Re: The Beach at South Inlet Proposed Mixed Use Development  
Block 132, Lot 1 and Block 133, Lot 1  
**Checklist Review for Completeness**  
**Preliminary and Final Site Plan Review Letter No. 1**  
ARH #24-10006

**TECHNICAL REVIEW LETTER NO. 1:**

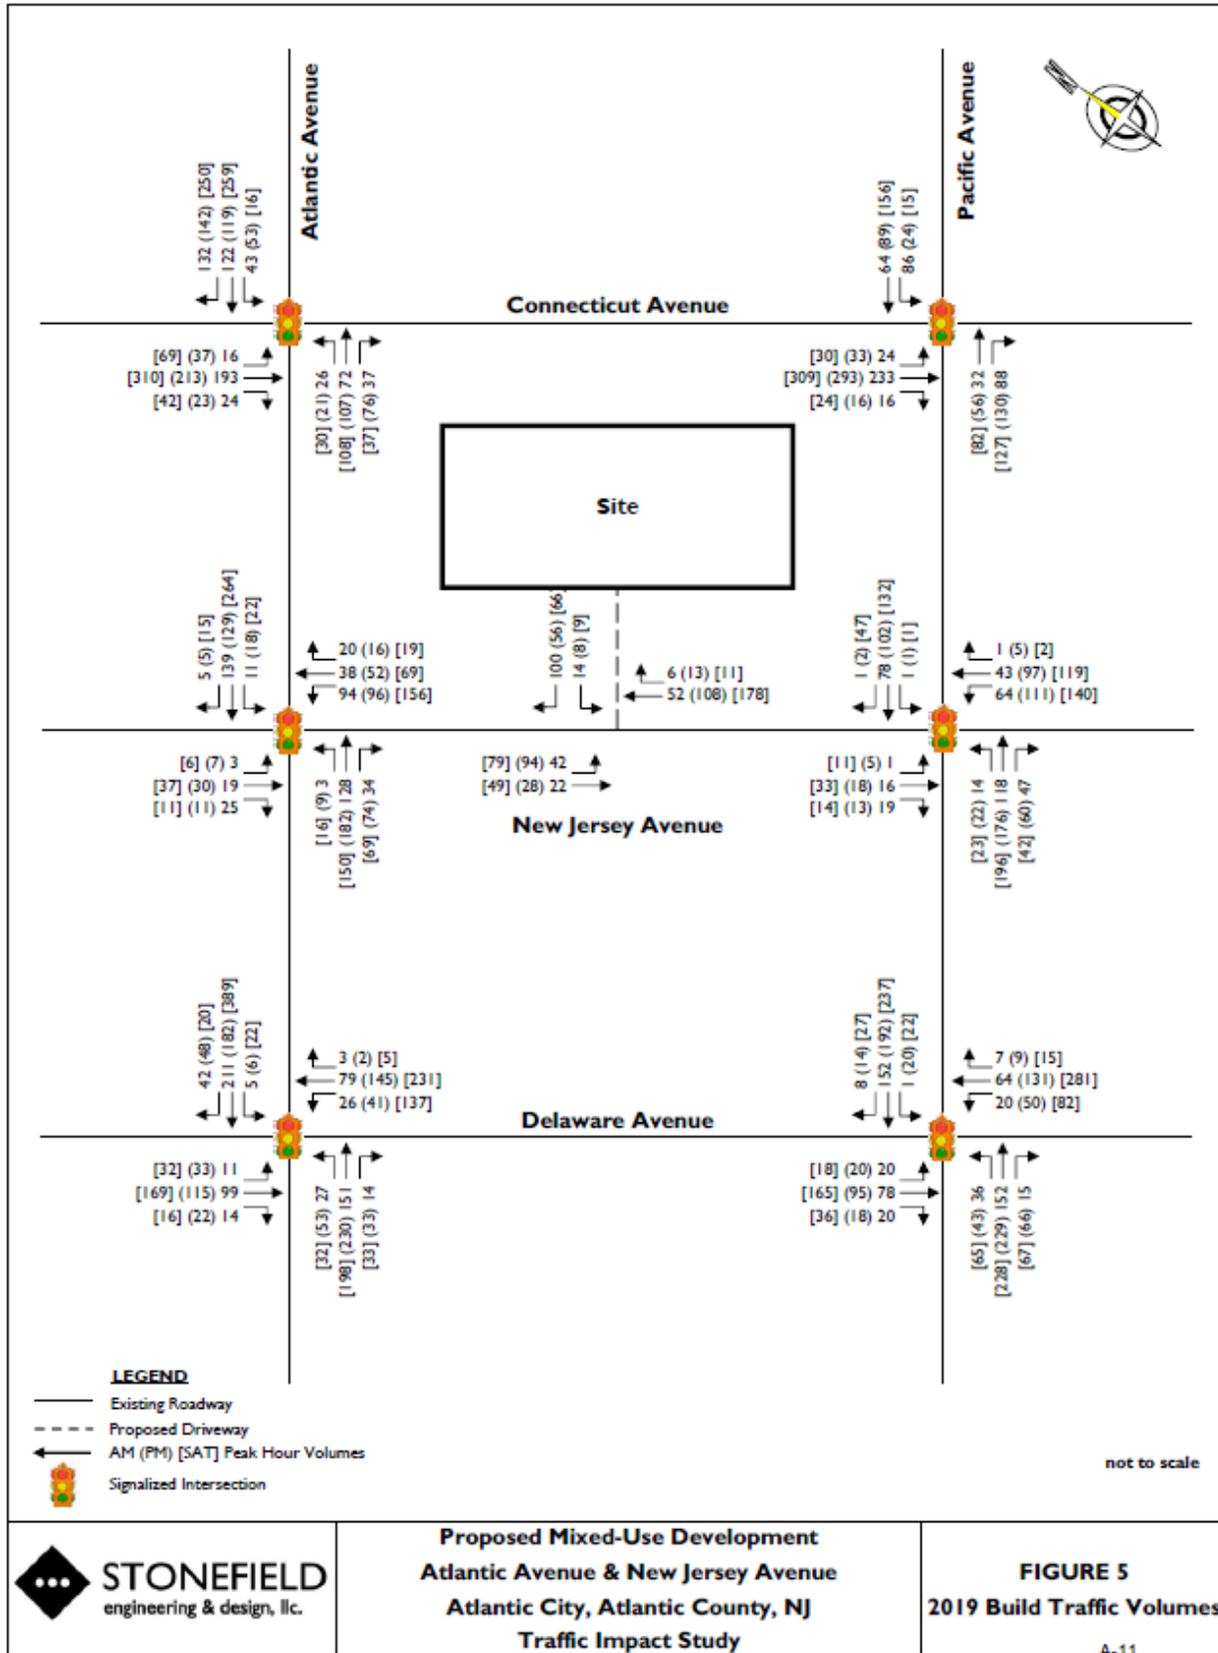
2. The site generated trips were added to the No-Build Volumes to calculate the 2019 build volumes. The values are shown on Figure 5 of the Traffic Report and included here for reference. With the development of the project, each signalized intersection studied will operate at LOS C or better, consistent with the findings of the no build condition.
